## **PART II: RESPONSE TO COMMENTS**

**Figure 8-1: Peak-hour Turning Movements – Green Street/North Street/Church Street**

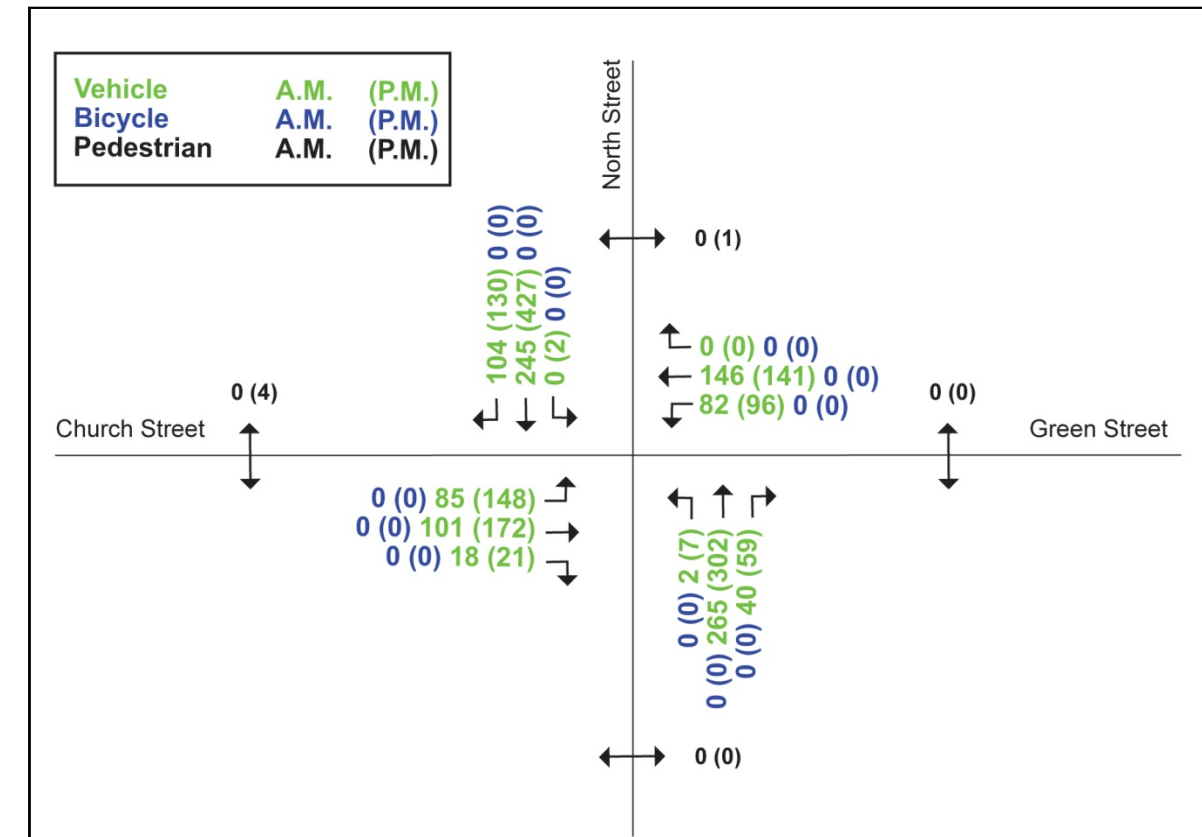
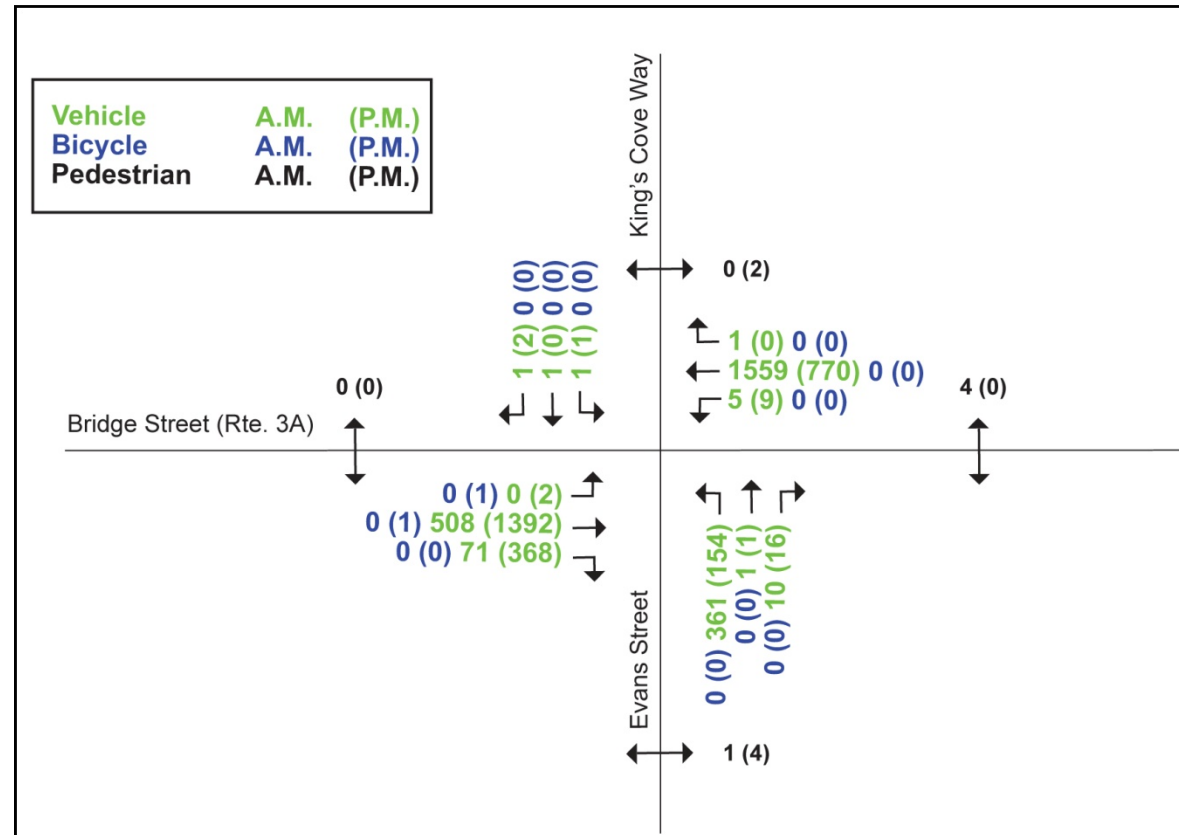
Manual turning movement (MTM) counts were taken at two intersections in Weymouth on Thursday March 24, 2011:

- Bridge Street (Route 3A)/Evans Street/Kings Cove Way (Location A); and
- Green Street/North Street/Church Street (Location B).

The study intersections were counted during the weekday a.m. (6:00 – 9:00 a.m.) and p.m. (3:00 – 6:00 p.m.) peak traffic periods. The results of the count confirm that the previously selected morning peak hour of 7:00 – 8:00 a.m. and evening peak hour of 5:00 – 6:00 p.m. are appropriate. Figure 8-1 shows the peak-hour volume at the Green Street/North Street/Church Street intersection and Figure 8-2 shows the peak-hour volume at the Bridge Street (Route 3A)/Evans Street/Kings Cove Way intersection.

The Bridge Street (Route 3A)/Evans Street/Kings Cove Way intersection is approximately 1,000 feet east of the Fore River Bridge and is the first signalized intersection east of the Fore River Bridge. When the MTM counts at this intersection were compared to the Fore River Bridge ATR counts, the peak-hour traffic volumes on Route 3A were found to be approximately equal, as expected.
